ADDENDUM # 4

Project	TA Blakelock High School Renovations	Project No.	2215-C
Location	1160 Rebecca Street, Oakville, ON	Date of Issue	2025 05 02
Owner	Halton District School Board	File	2215/7.1.3

This Addendum forms part of the Contract Documents and amends the original Drawings and Specifications, dated 2025 04 17, and all preceding Addenda, as noted below.

Drawing Title:
**LIBRARY WASHROOMS
AND ELEVATORS
NEW HVAC PLANS**

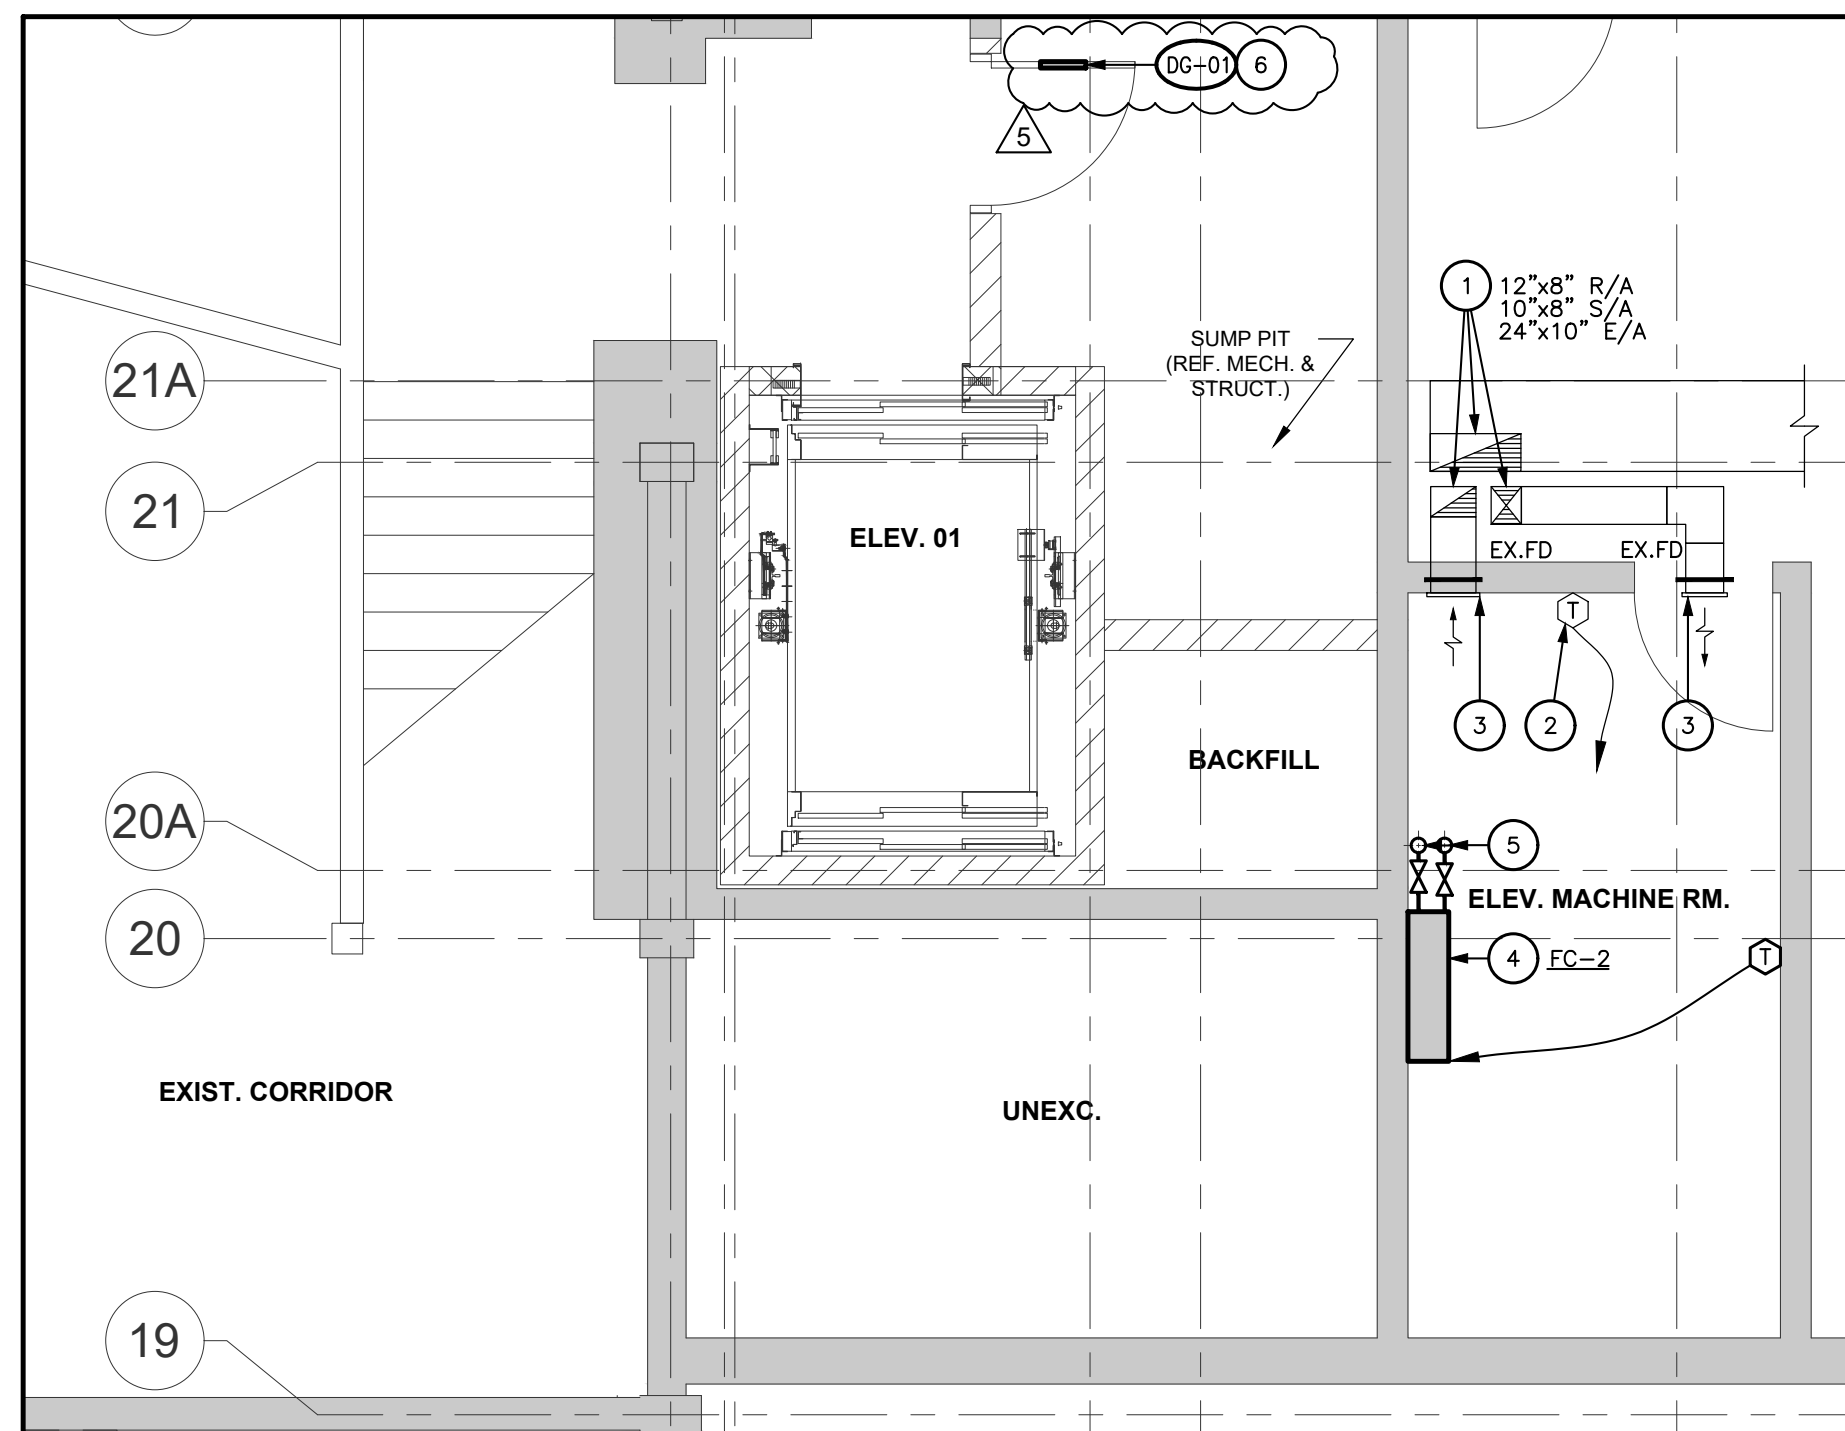
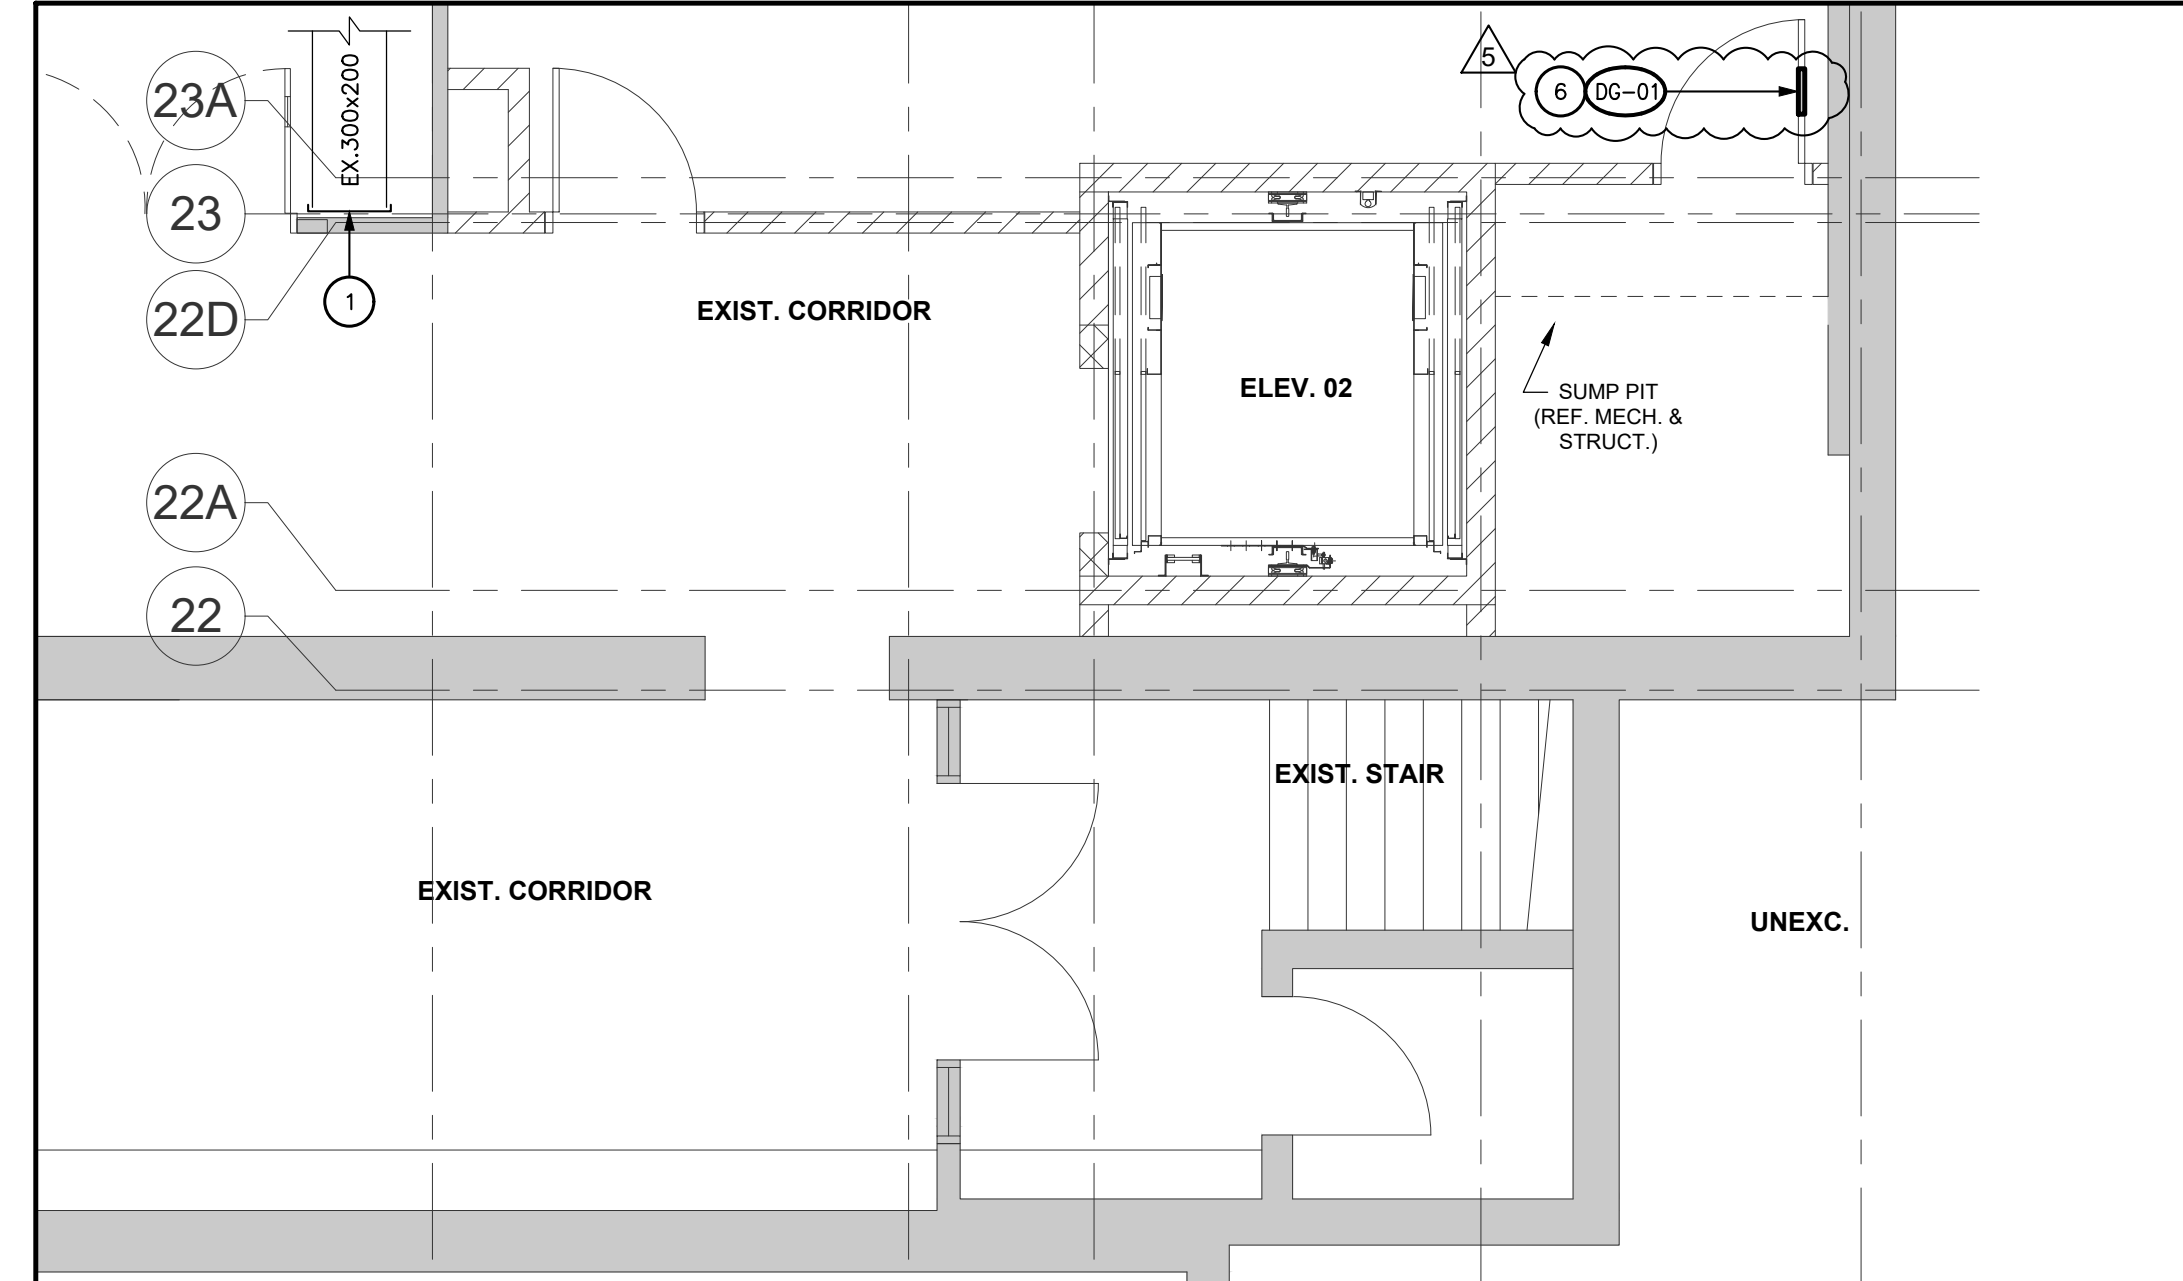
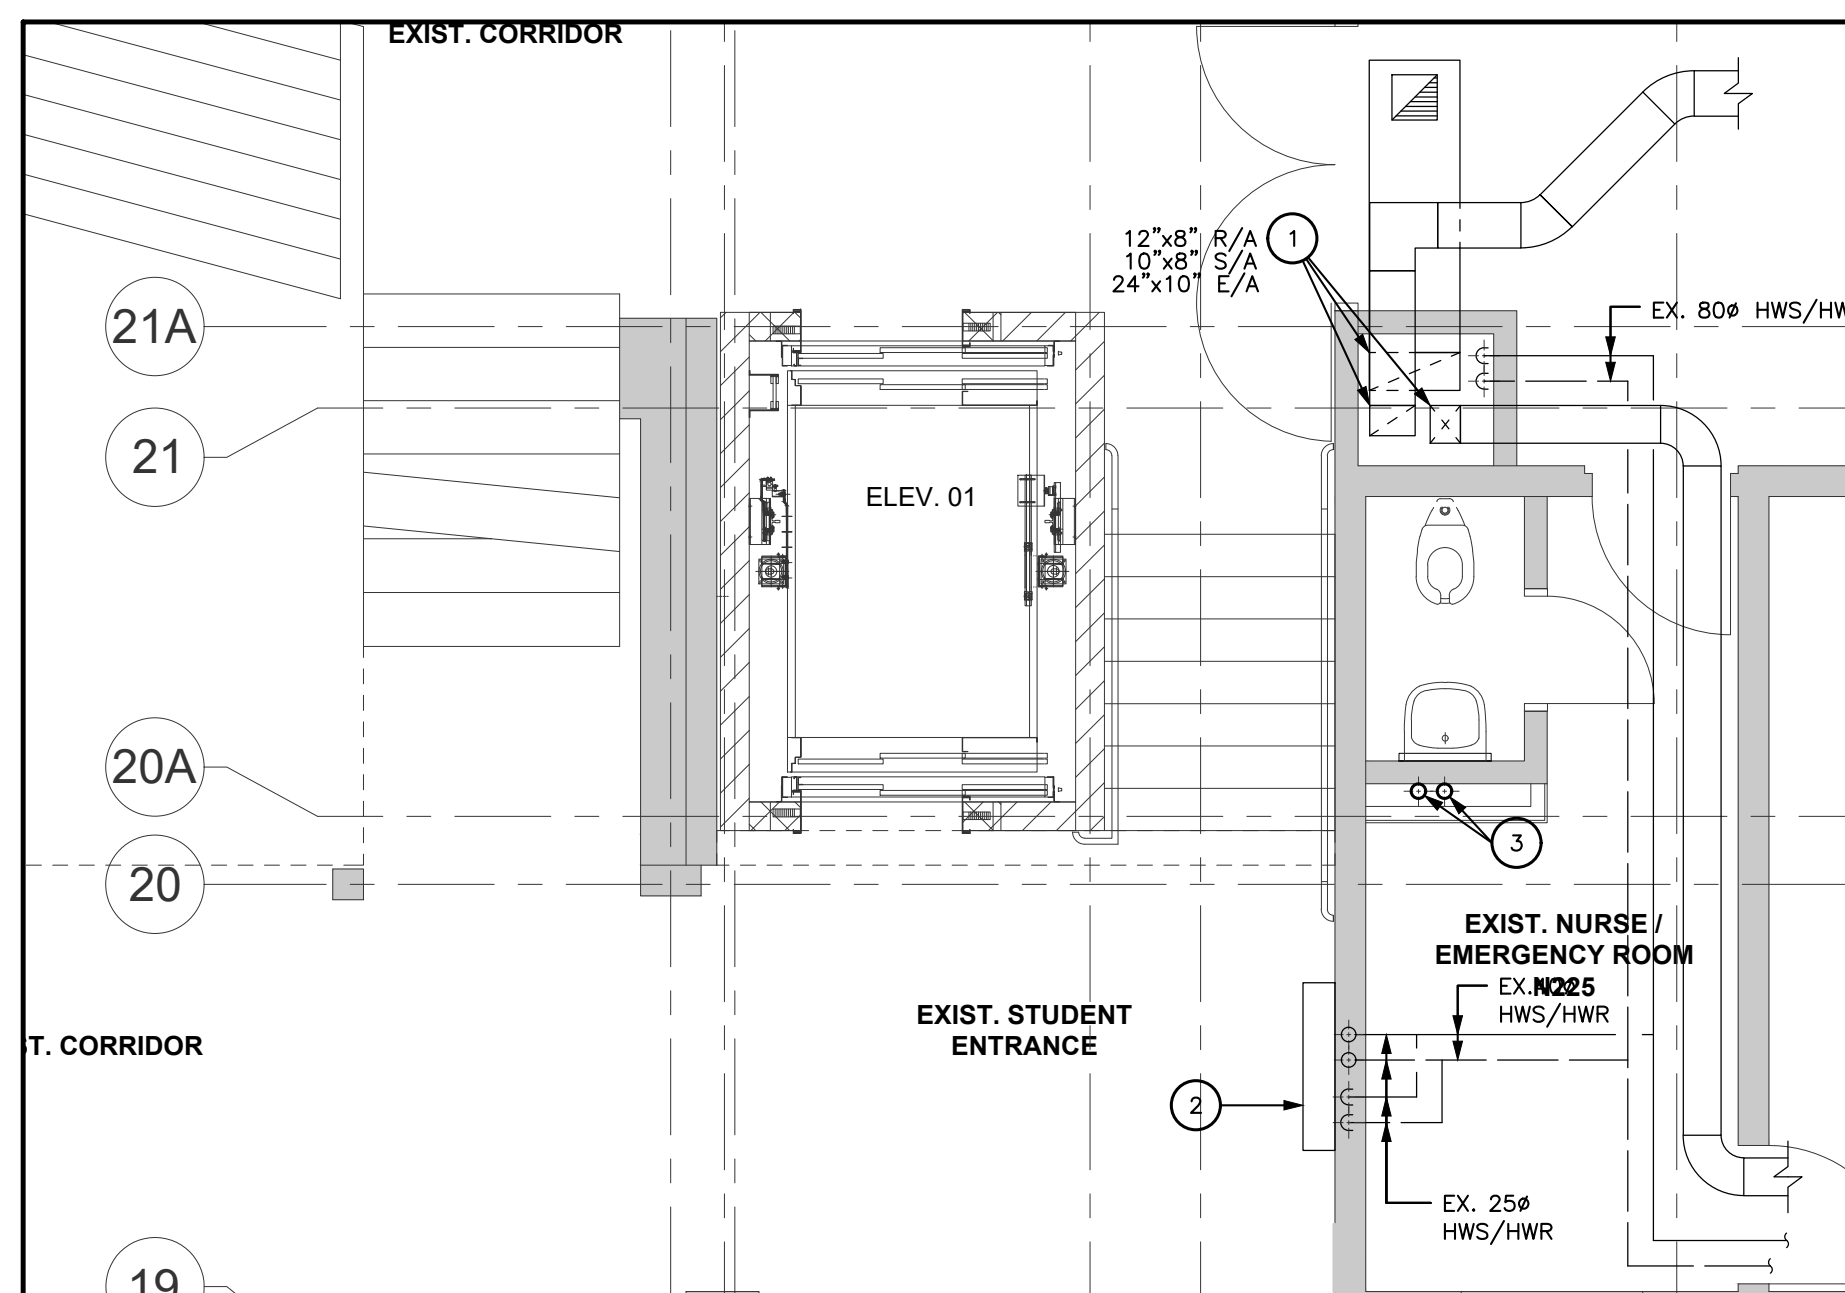
- .2 **Refer to Partial Level 0 Elevator 02 – Demolition Plumbing Plan:**
 - .1 **ADD** demolition of existing sink within millwork to be demolished.
2. **Drawing M300 – LIBRARY WASHROOM AND ELEVATORS NEW HVAC PLANS**

- .1 **ADD** Fire rated transfer grille to new door.
3. **Drawing M400 – MECHANICAL DETAILS AND SCHEDULES**
 - .1 Drawing is issued with this addendum. Modifications include, but are not limited to the following:
